Number C.1
Section Carburetters and
Fuel System

PETROL FUMES

(2.4, 3.4 and 3.8 litre Mark 2 models)

FIG 1

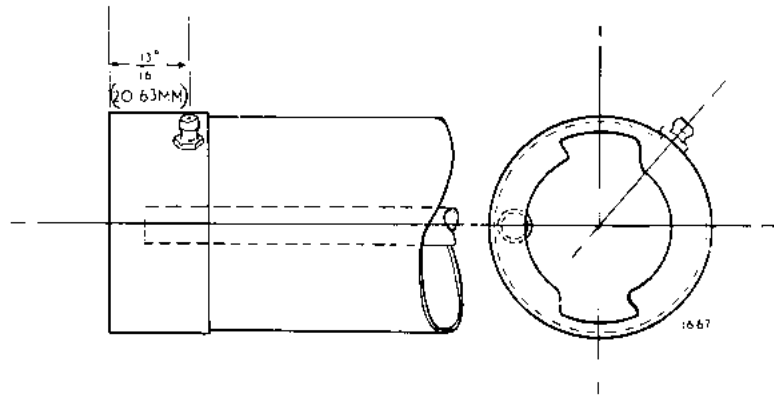
Using a No.3 .213" (7.69 mm) drill; drill a hole $13/16$ " (20.64 mm) from the top edge of the filler pipe as shown in Fig.1. Tap the hole $\frac{1}{2}$ " UNF. Coat the drill and tap with grease as a precautionary measure against pieces of metal falling inside the filler pipe.

FIG 2

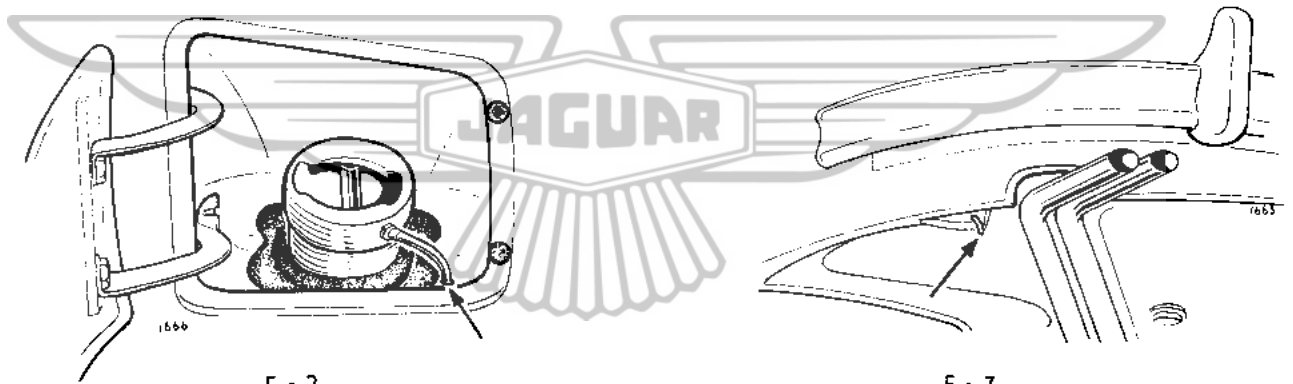
Drill a $\frac{1}{4}$ " (6.35 mm) hole in the floor of the petrol filler box as shown in Fig.2.

Press a piece of plastic tube $16\frac{1}{2}$ " (42 cm) long, Part No. C.8244, onto the grease nipple screwed into the petrol filler pipe, pass the plastic tube through the hole in the floor of the petrol filler box as shown in Fig.2. Pass the plastic tube through the hole in the side panel so that the end of the tube is facing away from the exhaust pipes as shown in Fig.3.

FIG 4

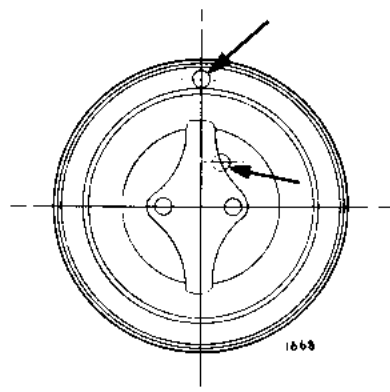
Blank off the two vent holes in the petrol filler cap with solder as illustrated in Fig.4.

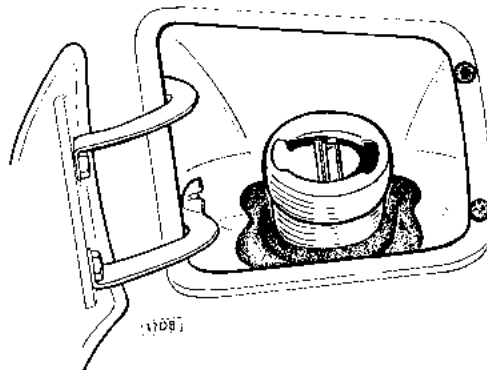
A modification to overcome petrol fumes has now been incorporated in production and consists of a breather pipe in the filler neck (adjacent to the vent pipe) and a non-vented filler cap. Cars so modified can be easily identified by removing the filler cap and noting if there are two pipes in the filler neck as shown in the illustration below; previous type petrol tanks have a single vent pipe in the filler neck.

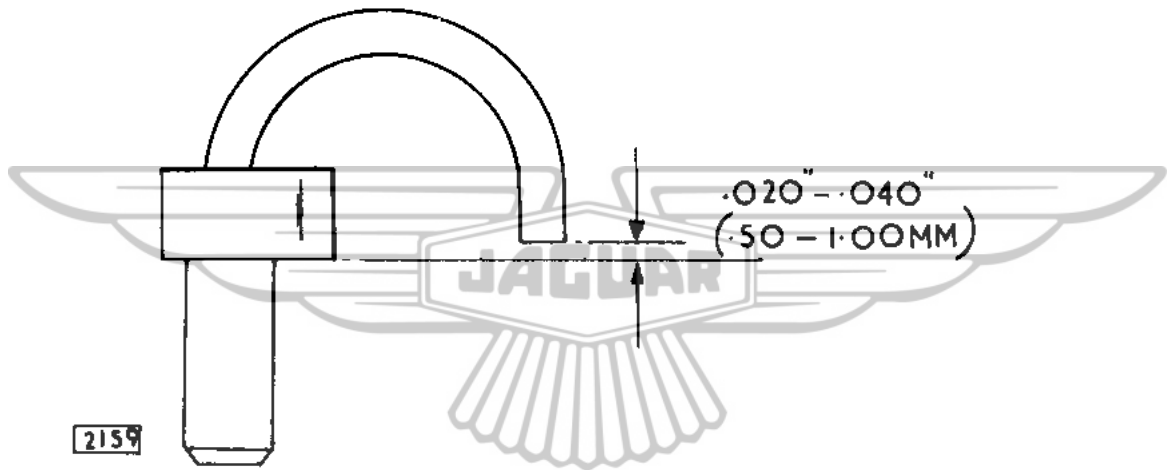
In cases of heavy fuel consumption on 2.4 litre cars, the usual checks on choke levers, throttle synchronisation, timing, tuning, etc., should be carried out but in addition the accelerator pump discharge injector tube should be checked for correct positioning.

The position should be checked by placing a straight edge across the lower face of the mounting block and measuring the gap between the end of the tube and the straight edge as shown in the illustration overleaf. The correct gap should be .020" - .040" (.50 - 1.00 mm). If this dimension is not correct, remove the assembly and fit a replacement (Part Number 5032) taking care to refit the gasket under the base of the assembly and tighten the locating screw. The injector tube must not be bent as there is a danger of loosening the tube in the mounting block.

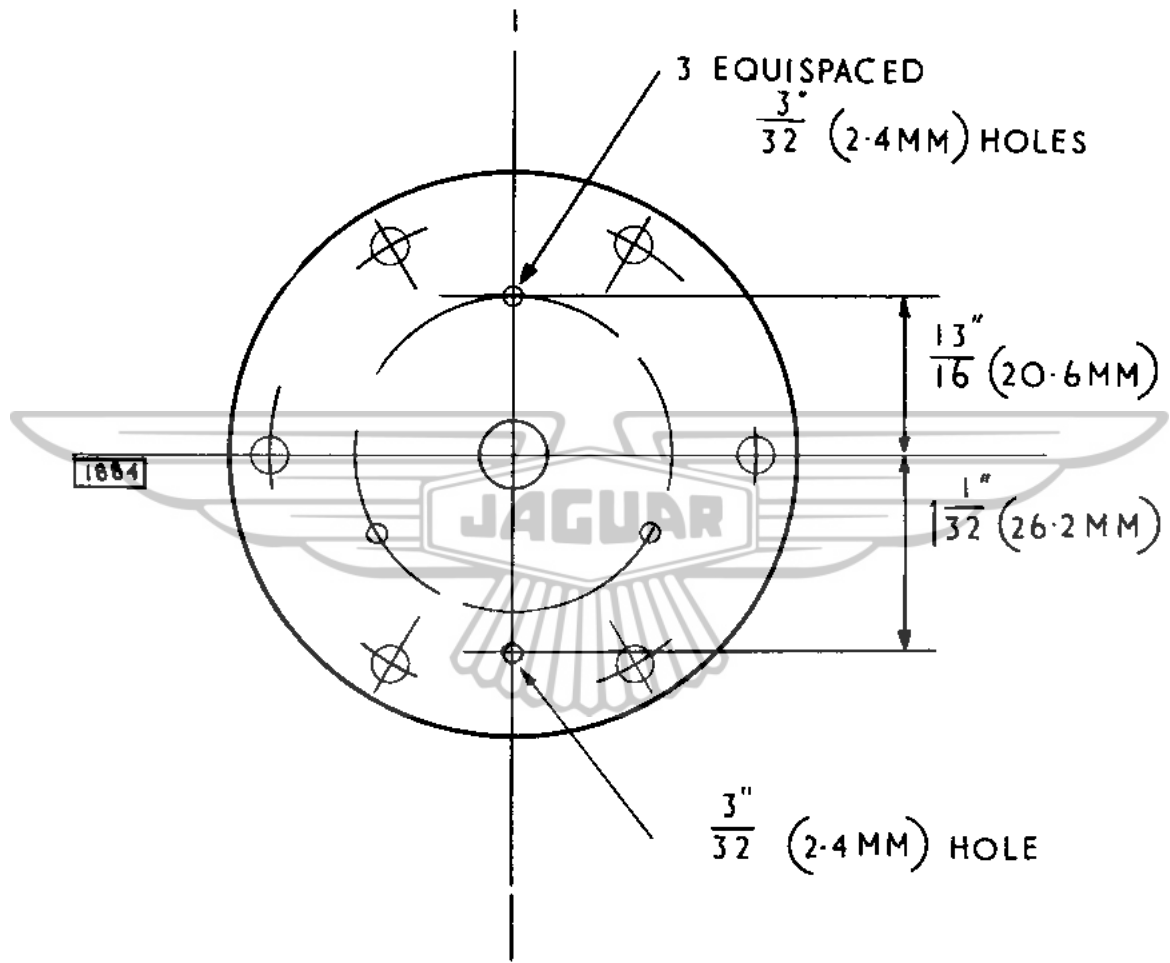
Whilst the pump is dismantled it is also advisable, particularly in hot climates, to pierce the upper diaphragm only (that is, the one next to the rollers) as shown in the sketch overleaf.

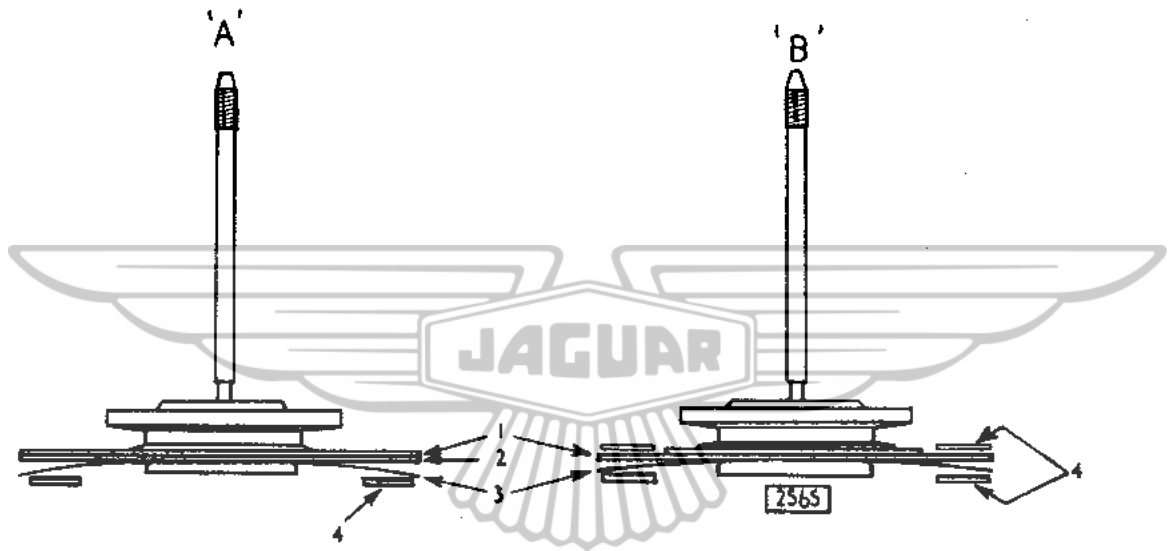
Cars with the AUB 152 type fuel pump (see Service Bulletin C.10) now have a modified type diaphragm (Part No. 9098 unchanged) "B" on the illustration overleaf. This diaphragm has a single neoprene leaf (Item 1) and a translucent plastic leaf (Item 3) and must be fitted with a gasket (Item 4) at each side of the diaphragm. Two gaskets will be supplied with each diaphragm.

The earlier diaphragm ("A" on illustration) has two neoprene leaves (Item 1 and 2) and a translucent plastic leaf (Item 3). This type of diaphragm had only a single gasket (Item 4) fitted.

If on cars prior to the introduction of the new diaphragm trouble is experienced with the pump failing to operate at temperatures below -7°C (22°F) either the latest type pump or the new single leaf diaphragm should be fitted.

If a new diaphragm is fitted it must be adjusted in accordance with the instructions given on pages C.22 and C.23 of the Mark 2 Service Manual except that the diaphragm must be backed off (unscrewed) 7 holes and not 5-6 as stated in the manual.

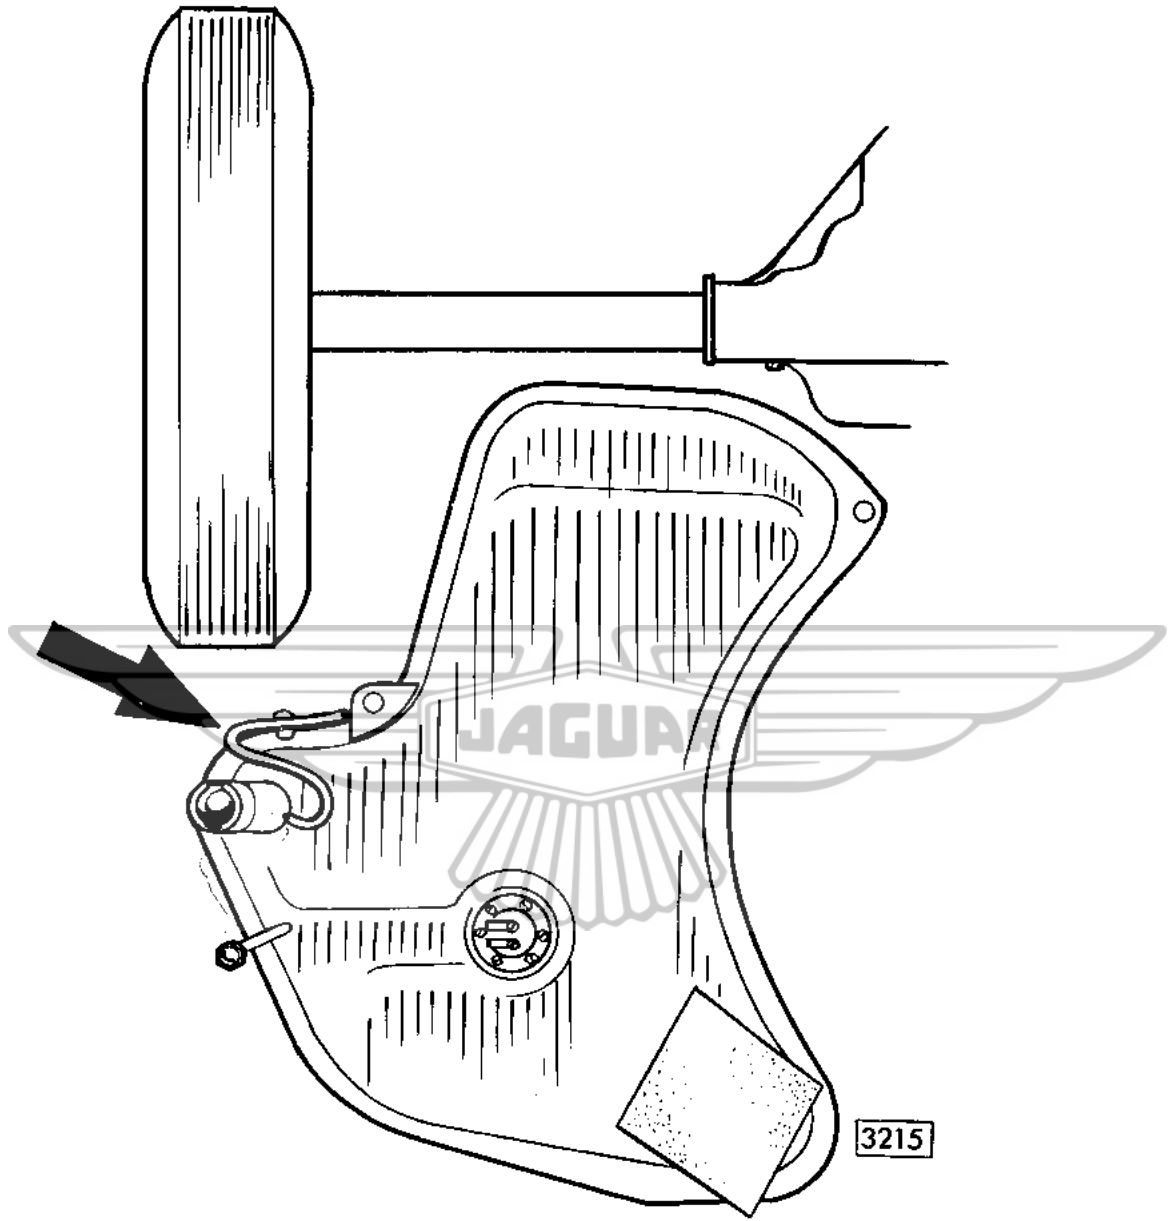
Cases have been experienced of petrol starvation due to the petrol tank breather becoming blocked with road dirt and also water entering the tank through the breather pipe.

In this event the breather pipe should be cleaned and if positioned to rear of the filler neck the pipe should be re-routed to the front and clipped to the petrol tank flange as shown in the illustration.
